Addendum to Technical Drainage Study for Centennial Subaru

March 2021

COMMENT LETTER

Subject: **Addendum to the Technical Drainage Study for Centennial Subaru**
CLV DS5416A
Parcel Number 125-28-510-004
Lochsa Job #201057

Onsite Section 'C' - 100year Cross Section for Irregular Channel

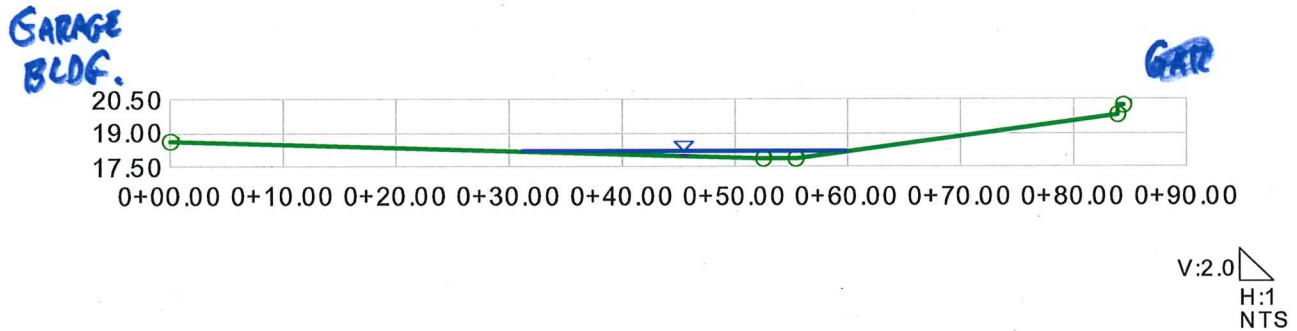
Revised Onsite Hydraulic Sections 'C' and 'D'

$$.33 \times .22 = .07 < 8 \text{ OK}$$

$$18.51' < 18.60' \text{ (GARAGE FF)}$$

FF meets ✓

BMP Swale Capacity

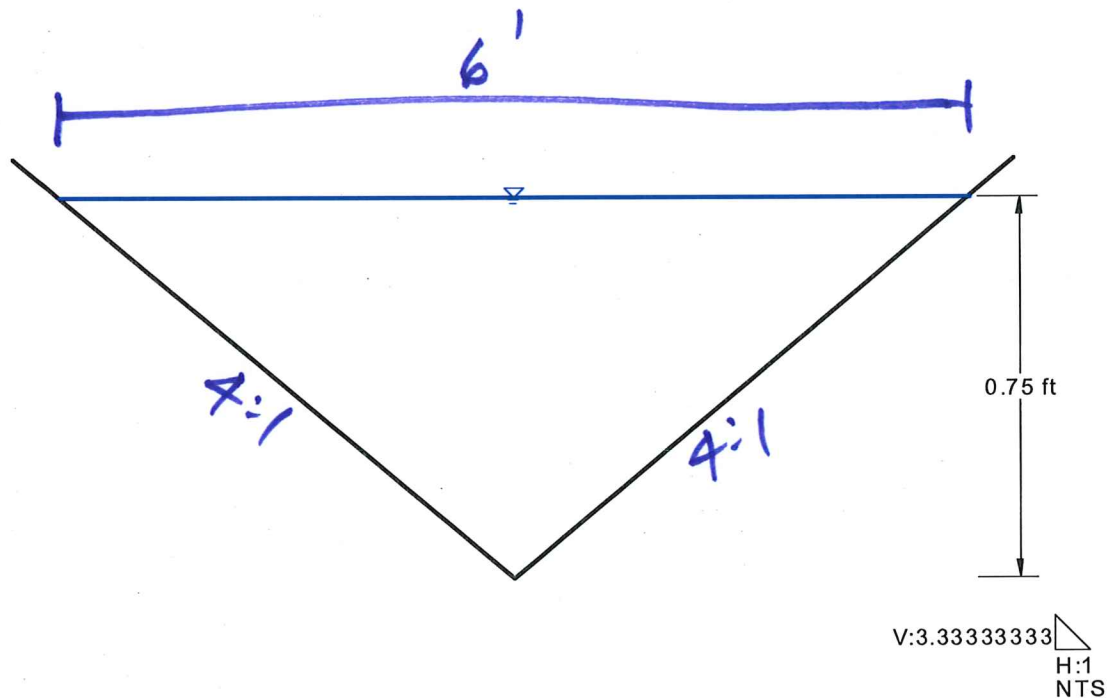
5. Only one calculation for the BMP swales has been provided, however there are several swales (5 total) proposed on the grading plans which they also vary in slope and flow acceptance. Provide calculations for the BMP swales.

Response 5: Our one calculation for the BMP swale was to show the worse-case capacity of the swale. BMP swales are used to only convey the 2yr flow per Section 1500 of HCDDM. They are not intended to fully convey the 100yr flow. The multiple BMP swales on site are designed to settle out sediment and pollutant of the water quality design flows, prior to exiting the project site. We have included the worse-case scenario for the capacity of one of our BMP swales at 1%. This shows our BMP swales can convey the 2yr flow of the drainage area that is discharging through each of them.

capacity > 2yr Flow for all BASINS onSITE

NON-EROSIVE
